EPA Comment

G-4 Plan for MgO Emplacement

**EPA Comment
G-8-2**

Figure 1. Comparison of SANTOS and SPECTROM-32 Results for Three Different Gas Generation Rates.

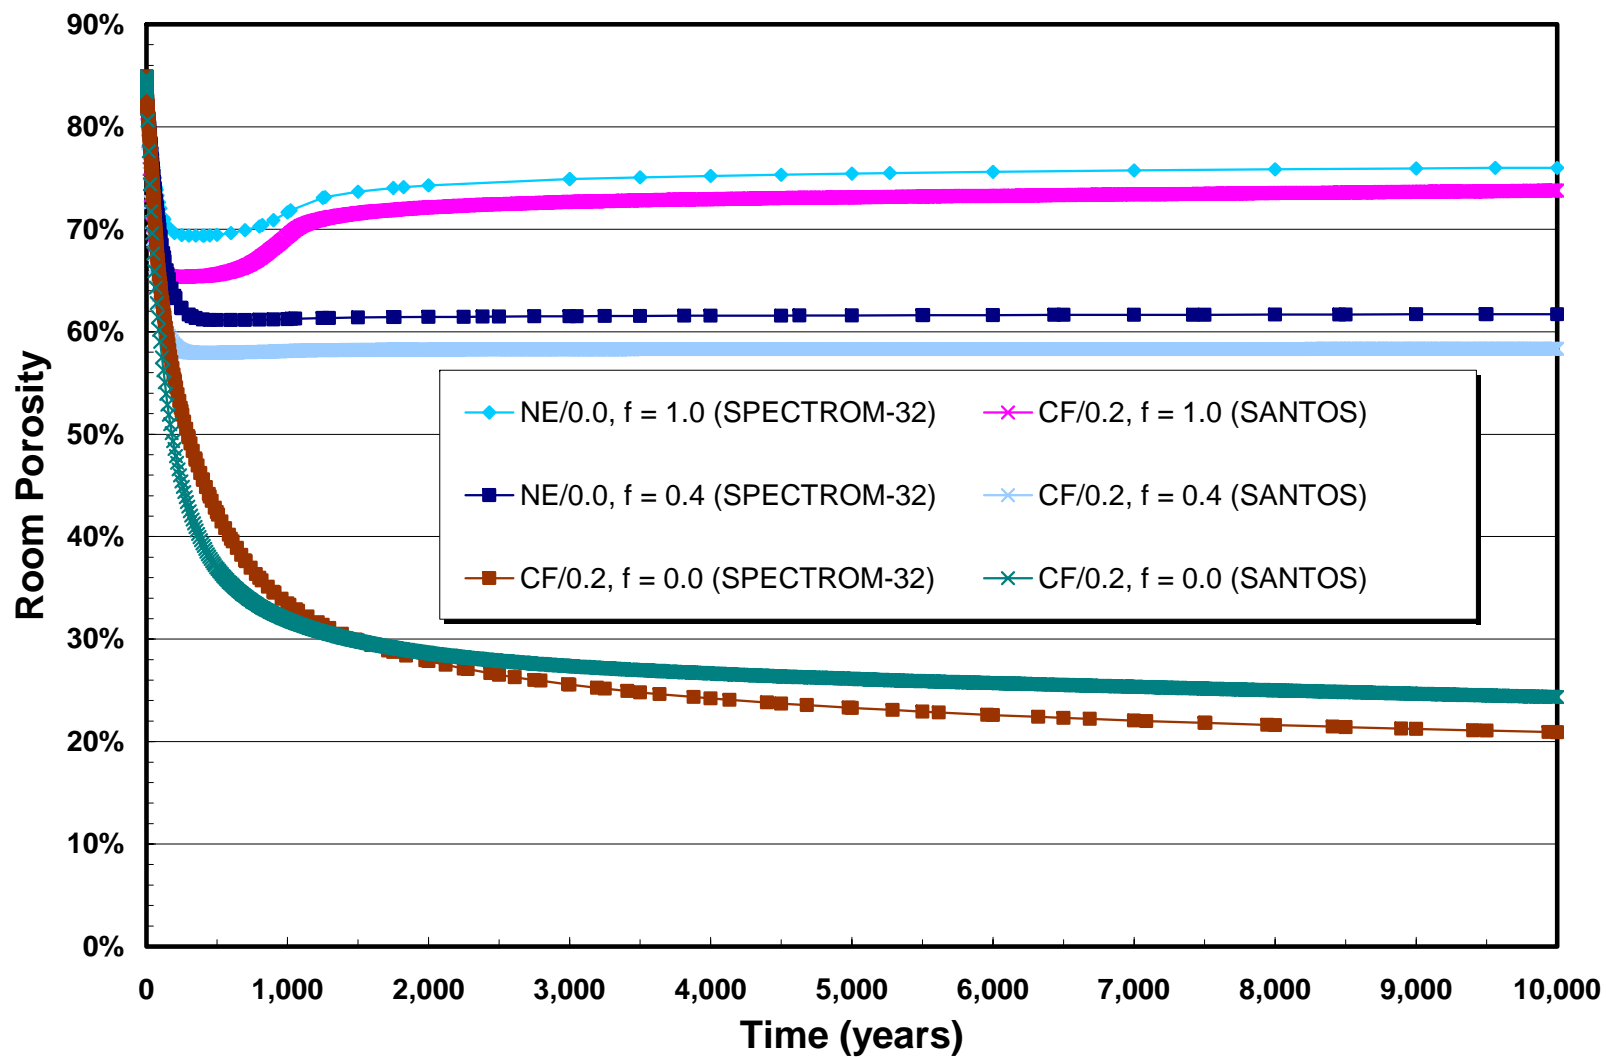
EPA questioned the accuracy of SANTOS and an important aspect of the accuracy determination resides within the waste constitutive model itself.

Figure 1 compares the average room porosity results obtained from SPECTROM-32 and SANTOS for three different problems. Figure 1 uses the following abbreviations:

Figure 1 compares room porosity results obtained with SPECTROM-32 and SANTOS for gas generation rates (f) of 0, 0.4, and 1. For the case with no gas generation, the SPECTROM-32 porosity results are slightly higher than the SANTOS results earlier in time and slightly lower than the SANTOS results later in time. At 10,000 years, the SPECTROM-32 and SANTOS results differ by about 3.4% room porosity (i.e., 20.9% versus 24.3%). For the gas generation cases ($f = 0.4$ and $f = 1.0$), the SPECTROM-32 results were computed using a nonlinear elastic model for the TRU waste with a Poisson's ratio of zero; whereas, the SANTOS results were generated using the crushable foam model for the TRU waste with a Poisson's ratio of 0.2. Despite these TRU waste model differences, the SPECTROM-32 and SANTOS room porosity results are quite similar with the SPECTROM-32 results being consistently higher than the SANTOS results. At 10,000 years, the SPECTROM-32 ($f = 0.4$ case) result is about 3.4% room porosity higher than the SANTOS result (i.e., 61.7% versus 58.3%). At 10,000 years, the SPECTROM-32 ($f = 1.0$ case) result is about 2.2% room porosity higher than the SANTOS result (i.e., 76.0% versus 73.8%).

Figure 1. Spallings Releases Calculated Using the Average Radioactivity Over All CH-TRU Waste Streams

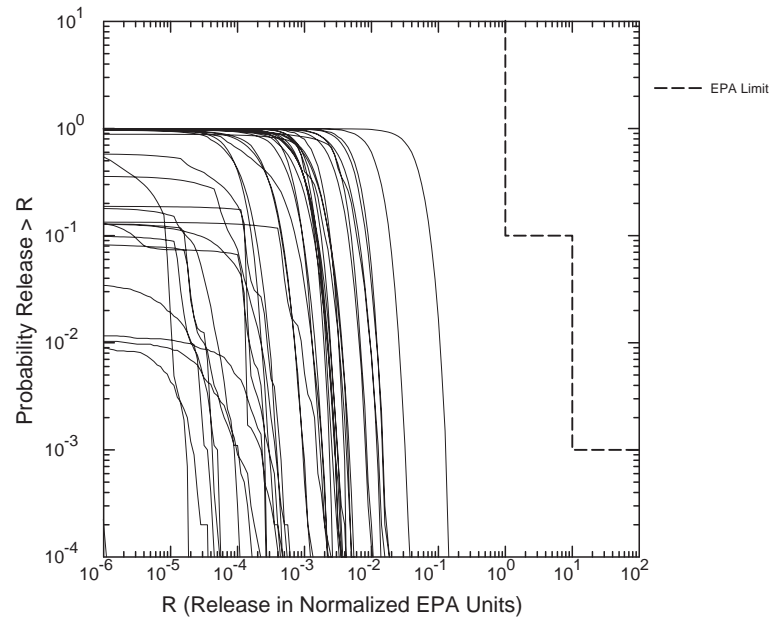
The CRA states that “spallings are assumed to be derived from a sufficiently large volume of waste that container-scale variability can be neglected.” While we accepted this assumption in the original certification decision, since then DOE has used a number of different container configurations—such as ten drum overpacks and supercompacted waste—with greater frequency than estimated earlier. In addition, the new DRSPALL code generally predicts much lower release volumes. For these reasons, neglecting container-scale variability may not be a valid assumption.

DOE must fully justify the existing waste spall model given the changes in waste container since the CCA and the new spallings model results or must rerun the CRA PA with assumptions that better reflect the container variation.

Figure 1 shows the 100 complementary cumulative distribution functions (CCDFs) for CRA Replicate 1 spallings releases that were computed using the average radioactivity across all CH waste streams. Fifty-eight of the 100 vectors fall off-scale with values too low to plot. Figure 2 shows the 100 CCDFs for CRA Replicate 1 spallings releases that were computed using the randomly sampled waste streams. Fifty-seven of the 100 vectors fall off-scale.
